Subject: Exelon Nuclear Texas Holdings, LLC  
Victoria County Station  
Response to Request for Additional Information Letter No. 01  
NRC Docket No. 52-042

- RAI Question 02.05.01-1 Basic Geologic and Seismic Information

**RAI Question 02.05.01-1**

**Figure 1:** Profiles 4 through 8 from SSAR Figures 2.5.1-50b and 2.5.1-50c shown with no vertical exaggeration (i.e., 1:1 horizontal to vertical scale). Zones of potential deformation indicated in this figure are the same as in the original SSAR figures.

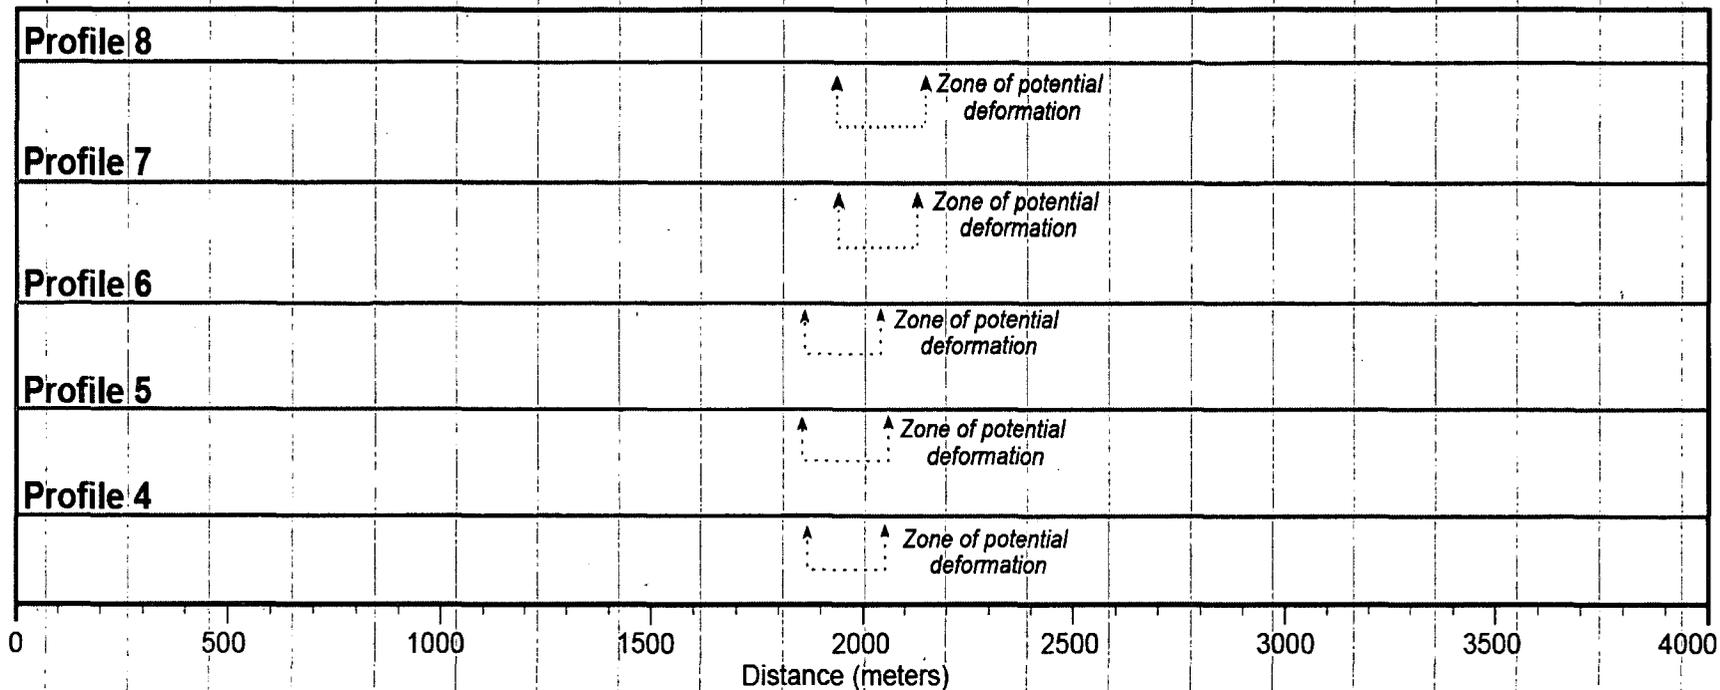
In FSAR Section 2.5.1.2.4.2.3 and 2.5.3.4.2 you describe growth fault D that breaks and offsets the current land surface and is located approximately 509 ft. to the southeast of the VC power block building. Growth fault E also breaks the surface but is farther away from the power block building. In accordance with Appendix C.2.4 and Regulatory Position 1.4 of Regulatory Guide 1.208, please provide the following information about the faults.

- a. Clarify the distance from Fault D to the planned power block area.
- b. Provide additional details on the movement history of growth fault D, including a justification for your assumption that the slip is continuous.
- c. Provide additional details on the calculation of slip-rate.
- d. Provide a discussion about your investigation on the age of the current land surface and the soil sequences over the surface expression of the fault.
- e. Provide a discussion about estimates of age of fault activity based on soil horizon evolution or soil catenas across the fault zone (McAlpin et al., 2009, p-251).
- f. Provide a discussion about the possible fault scarp at the surface. Include an estimate of time since last movement based on a fault scarp degradation analysis (McAlpin et al., 2009, p 247).

The variation in topography is so minor across the zone of surface deformation associated with both growth faults D and E (Figure 1) that the soils on the deformed surface would not be subjected to different rates or styles of soil-forming processes. Because different rates or styles are necessary to form a soil catena, variations in soil characteristics across the zone are not expected. The age of soil horizons on the tilted land surface are also not thought to be able to constrain the timing of deformation associated with the growth faults, because soil development is not likely to have been impacted by the formation of the subtle monoclinal folding or tilting (e.g., steepest slopes of  $< 0.5^\circ$ ). However, an analysis of soil maps for the site area (Miller 1982; USDA 2010) is described below.

As discussed above, there is no observed fault scarp associated with either growth fault D or E. Instead, the faults are associated with broad, low-amplitude, monoclinical folding and/or tilting (Figure 1). As such, it is not appropriate or feasible to use diffusion dating, a method premised on the rate of erosional degradation of a scarp formed by discrete surface fault rupture, to estimate the age of the surface deformation. The primary reasons why diffusion dating and other methods cited in the reference provided in the RAI question (McCalpin 2009) are not appropriate include:
